MEMORANDUM

RE: Application of Raymond and Amy Butler (P2014-39)

Summary

Exhibit 14 – simulations of newly planted trees (left) and mature trees (right)

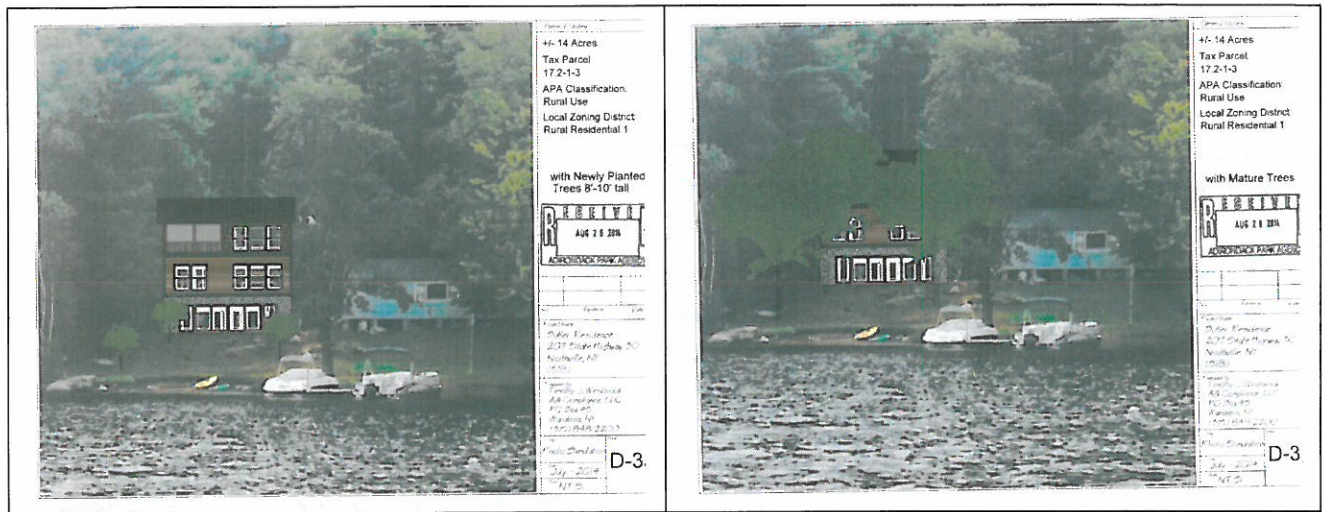
The proposed planting of 8- to 10-foot-tall trees would not substantially ameliorate the adverse visual impacts of the proposed dwelling for 20± or more years after planting.³² In addition, staff believe a minimum of five trees are needed to provide adequate screening over the long term.³³ Due to the small size of the variance site and proximity of the dwelling to HRBRRD lands, the trees cannot be planted on the variance site.³⁴
